Subject: Liquefaction Analysis - Midland

SUBJECT: CORP OF ENGINEERS REPORT AND REQUEST FOR ADDITIONAL INFORMATION  
ON PLANT FILL

SUBJECT: Interagency Agreement No. NRC-03-79-167, Task No. 1 - Midland Plant  
Units 1 and 2, Subtask No. 1 - Letter Report

SUBJECT: Effect of Plant Fill on Seismic Ground Motion Environment at the  
Midland Michigan Nuclear Power Plant

Figure 11. Shock Spectra Calculated for the Surface of Three Different Soil Profiles Using the Fogaria Record

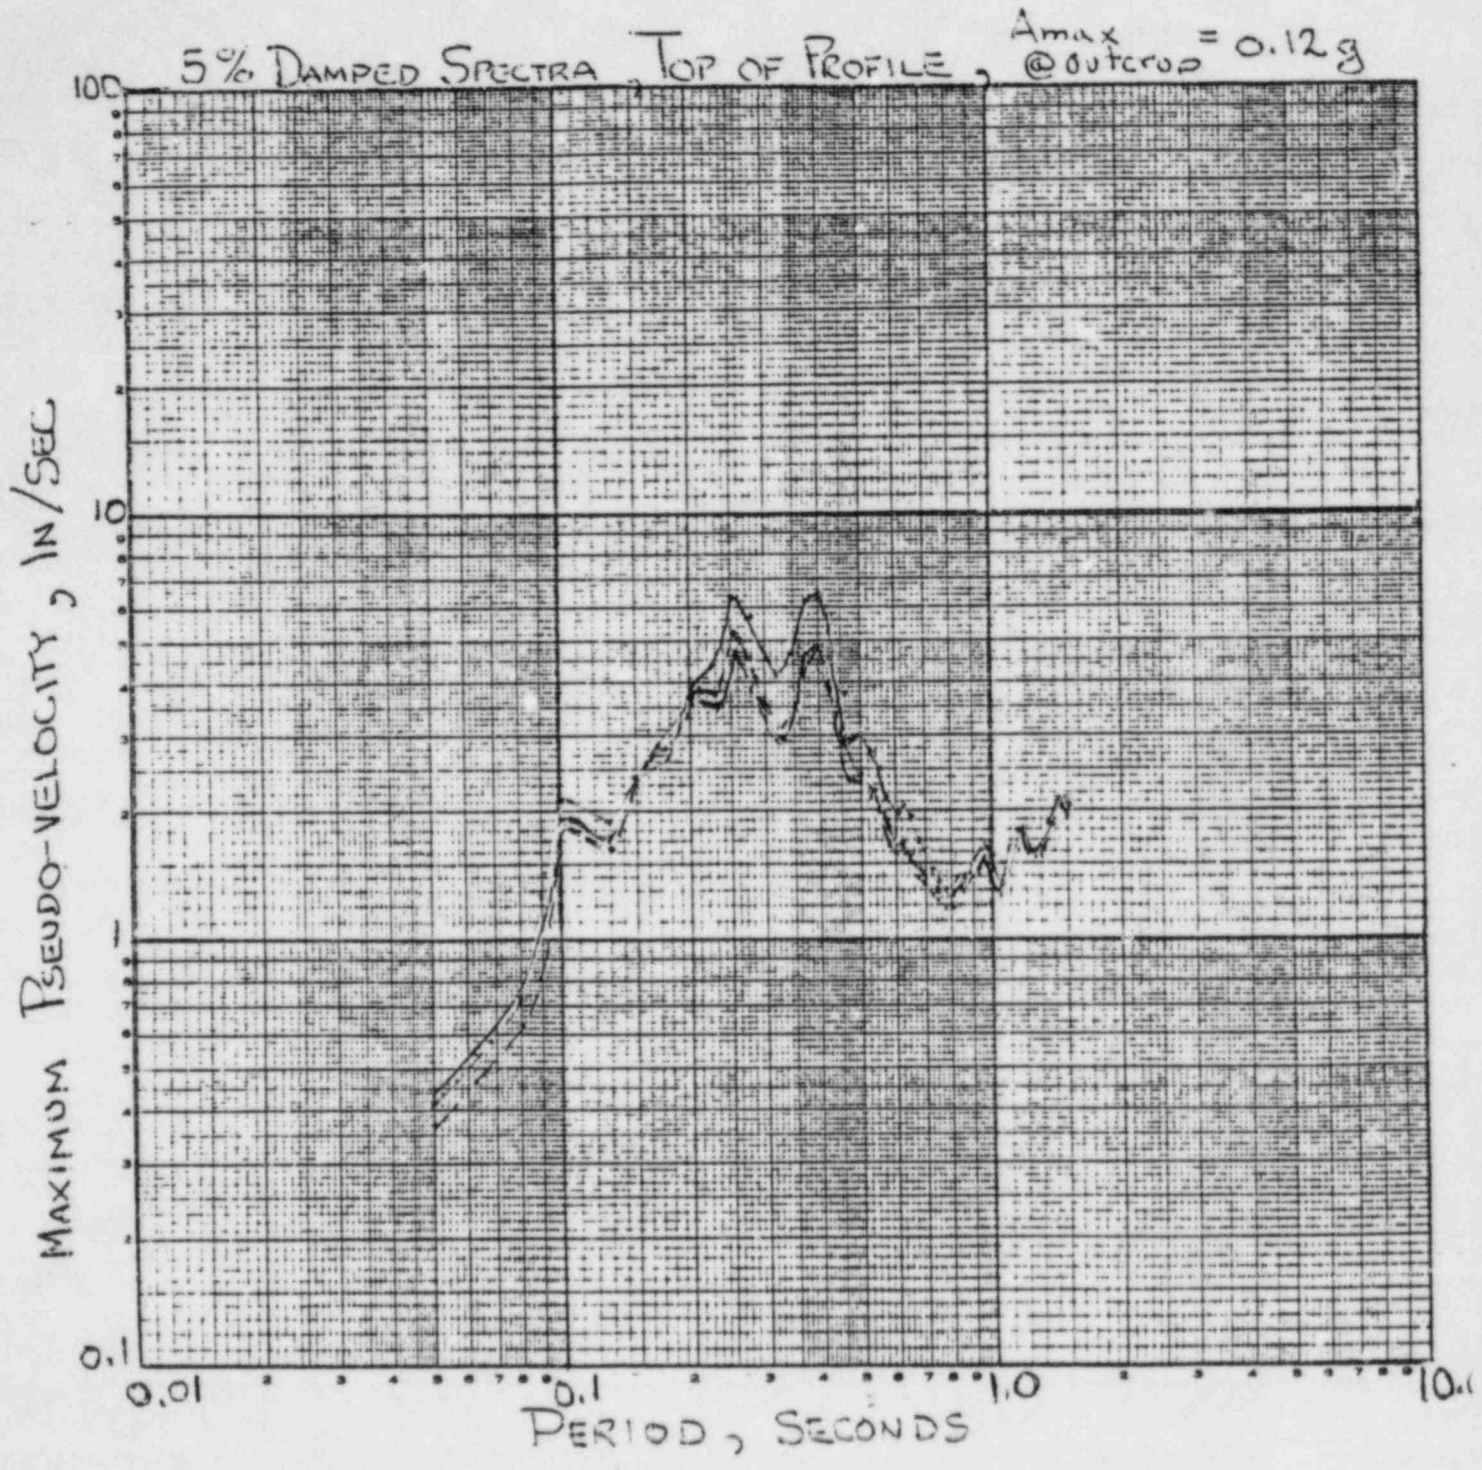
19. Figure 11 shows the spectra for the same 3 cases. The top of fill spectra for Profile G is essentially the same as that for the original ground surface (Profile H) while that for Profile F shows some amplification in the 2-5 Hz frequency range. Since the acceleration record, soil profiles and outcrop are all physically reasonable with respect to the assumptions made in the development of the empirical site specific response spectra, a comparison with transparency of Figure 6 is appropriate. Such a comparison shows that except for two very slight excursions, the spectra in Figure 11 are all below the 84th percentile empirical spectra for the top of fill.

24. SUMMARY. The analytical parameter study has shown that the effect of the addition of the fill on the ground motion environment can be different depending on the stiffness of the fill, the acceleration record chosen, or which layer is chosen for the outcrop. The largest variations observed in the top of fill ground shock environment occurred due to the change from Profiles A to F (or I to H). This represents a major change, not just in the fill but in the top 50 ft of original ground. The combined effects of making the site properties more realistic was to raise the shock environment (Figure 8). The second major variation was the result of changing outcrops. In general, changing from Saginaw to till as the outcropping layer decreased the shock environment substantially (compare Figures 8 and 9; see also Figure 14). The effect of stiffening the fill only was to decrease the shock environment at the top of the fill (Figure 11) by a modest amount.

Figure 12. Amplification Factors Calculated Using Parkfield Record

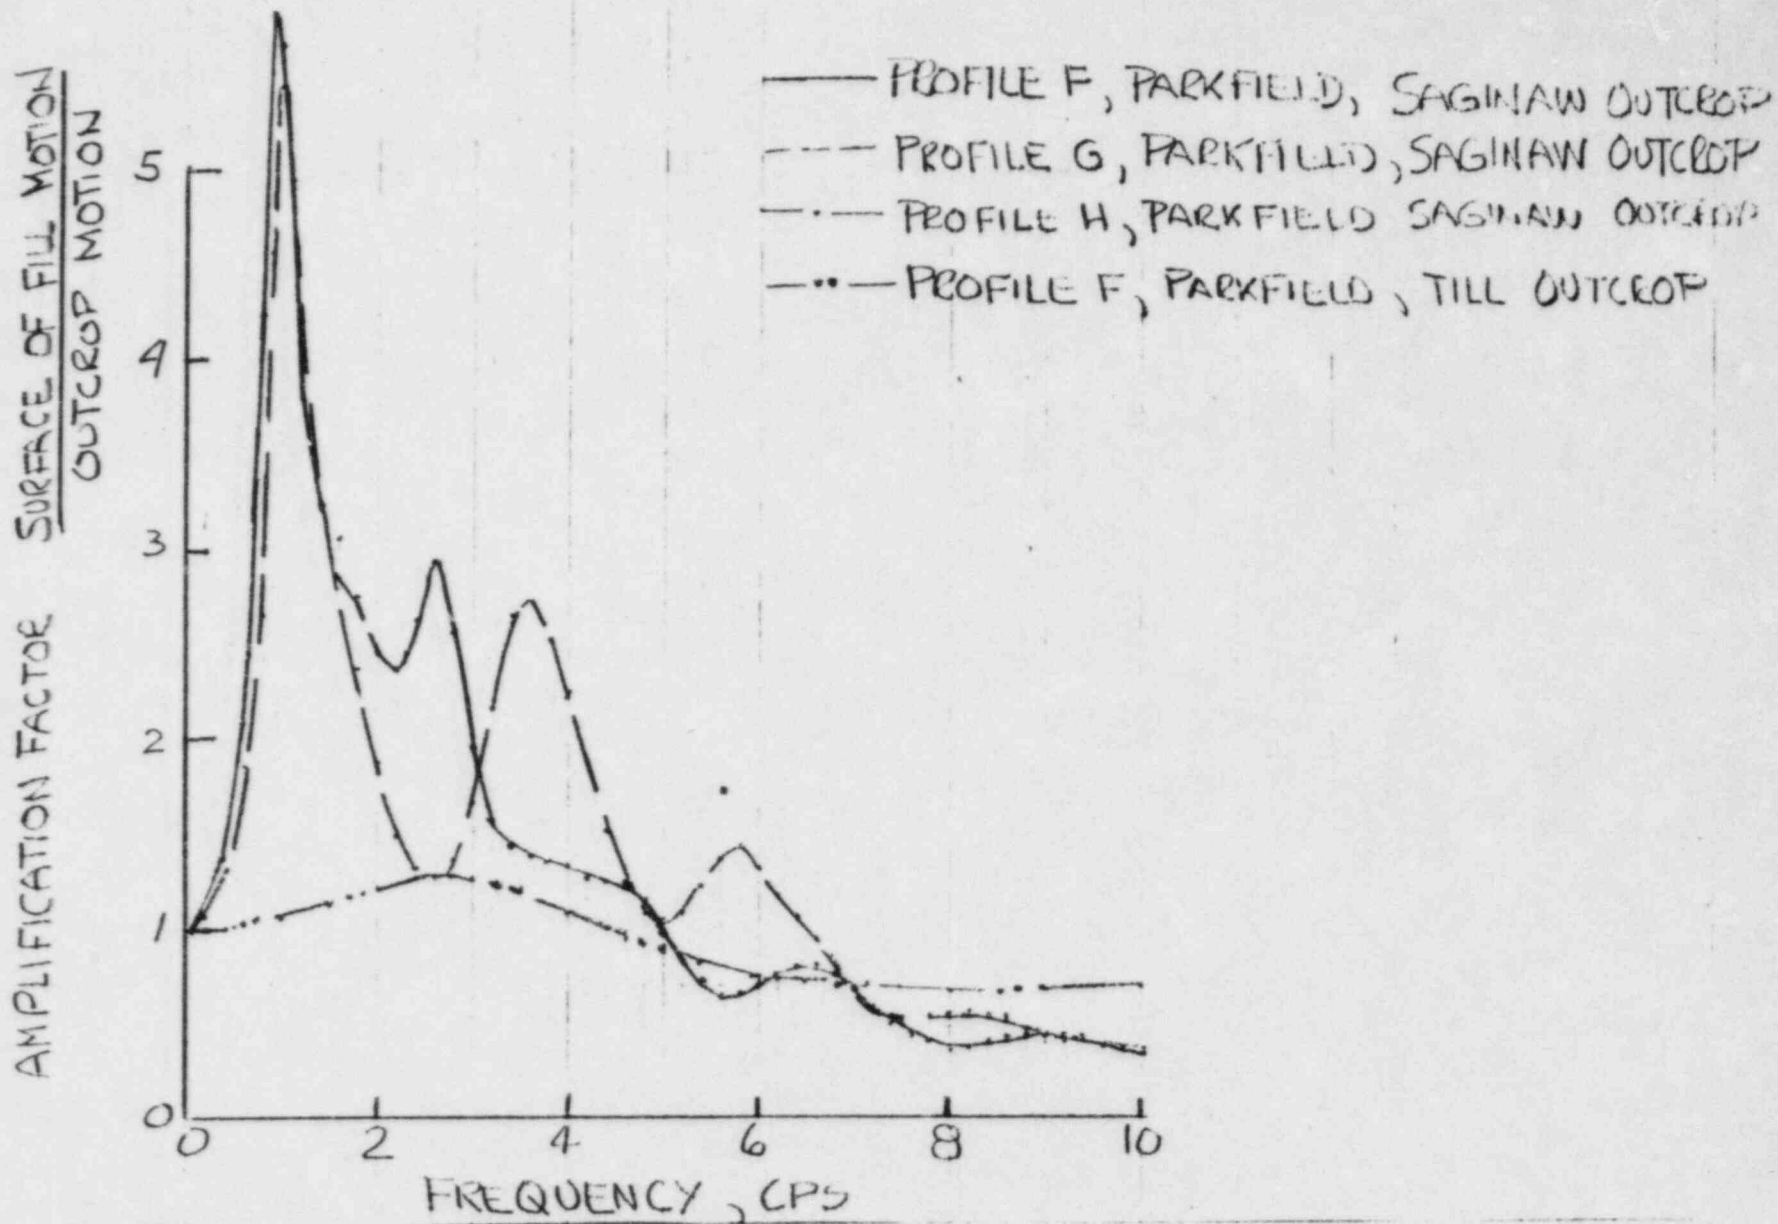
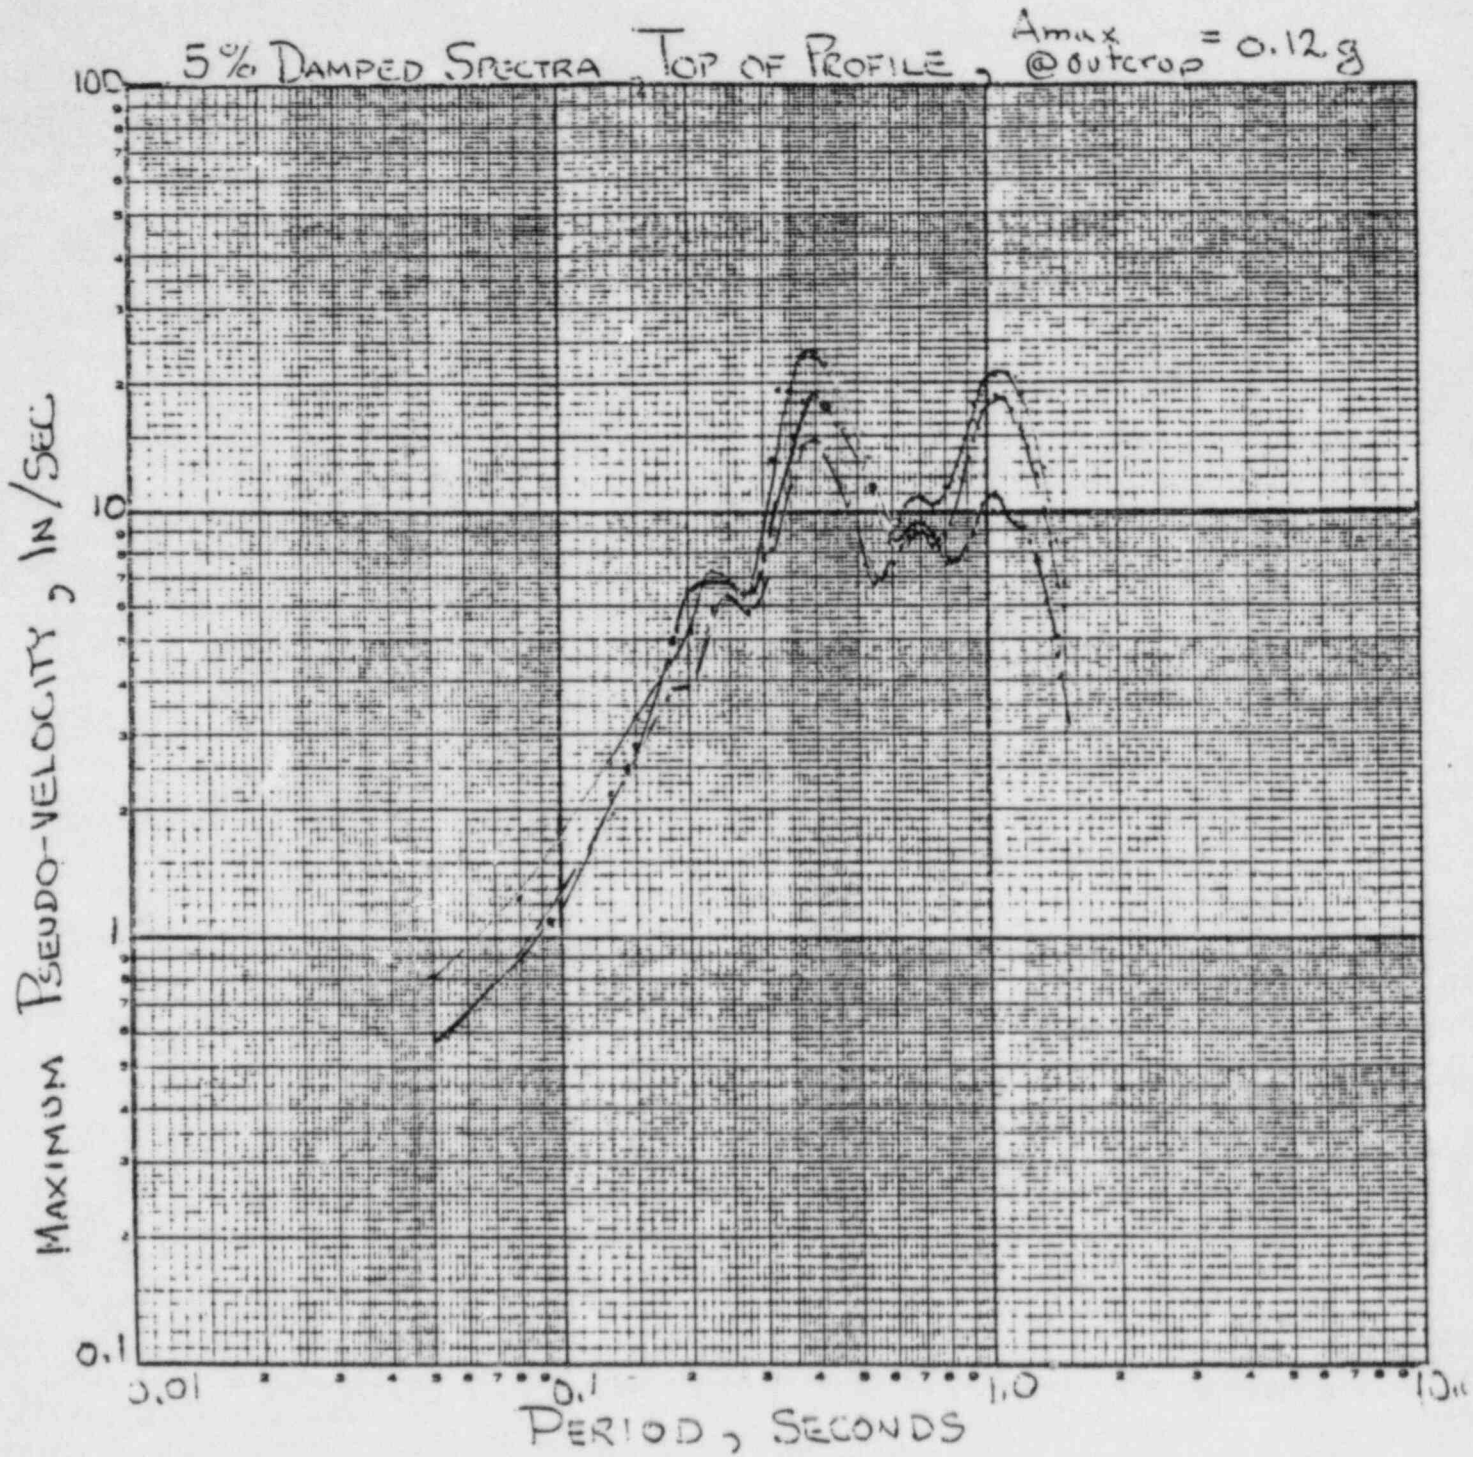
21. Figures 12 and 13 show the amplification factors and shock spectra computed using the Parkfield-Temblor record. The figure shows substantial amplification due to the fill at frequencies up to 4 Hz and the spectra showed in Figure 12 exceed those in Figure 6 substantially in the range below 5 Hz. It should be expected that, if the seismologists decide the Parkfield-Temblor record and others like it should make up a substantial part of the data set for an empirical analysis, then the empirically developed spectra for the plant fill would exceed that in Reference 3. Reference 9 showed that such was also the case for the spectra for the original ground surface.

Figure 14. Effect of Selection of Outcropping Layer on Spectra for the Parkfield-Temblor Record

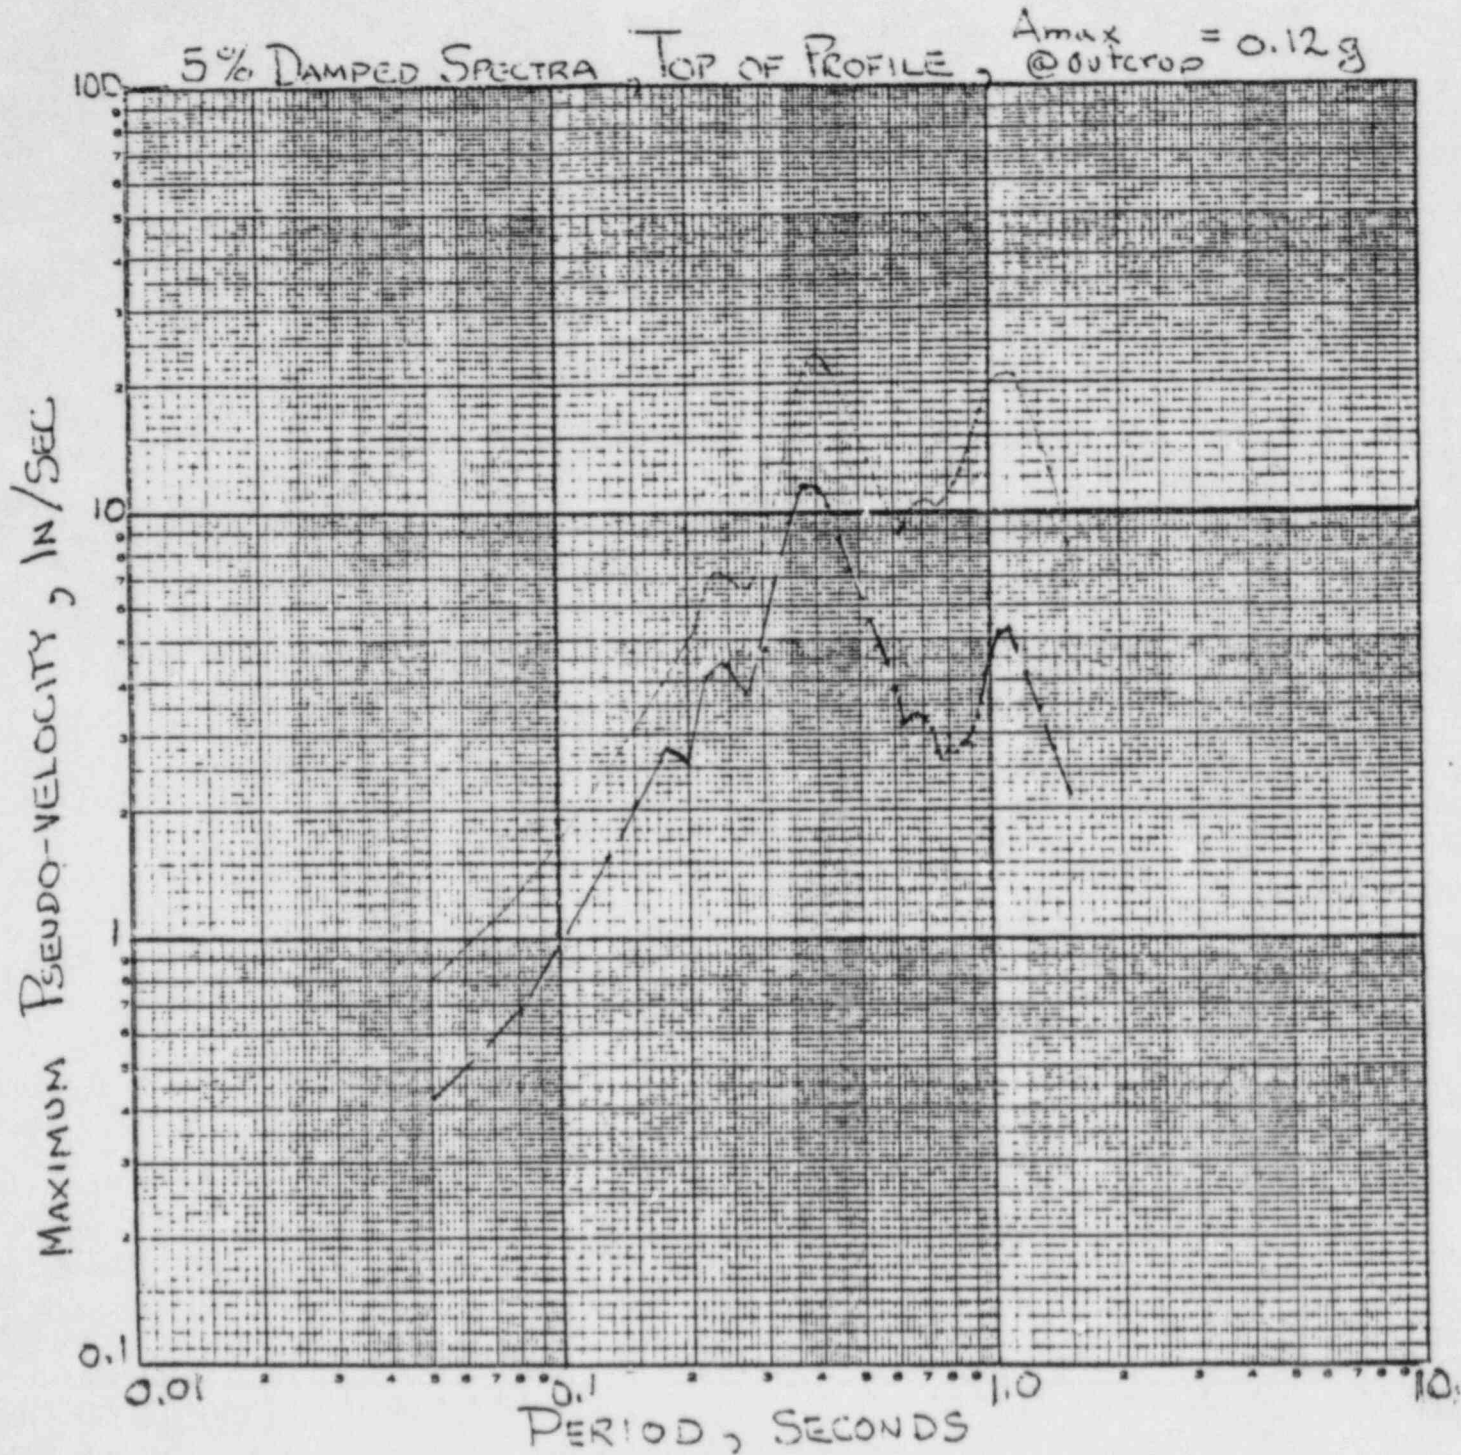
22. Figure 14 shows the largest effect of any single variation made in this study. Changing from a rock outcrop (which is appropriate for the Temblor record) to a till outcrop substantially decreased the shock spectra amplitudes in the entire region of interest.
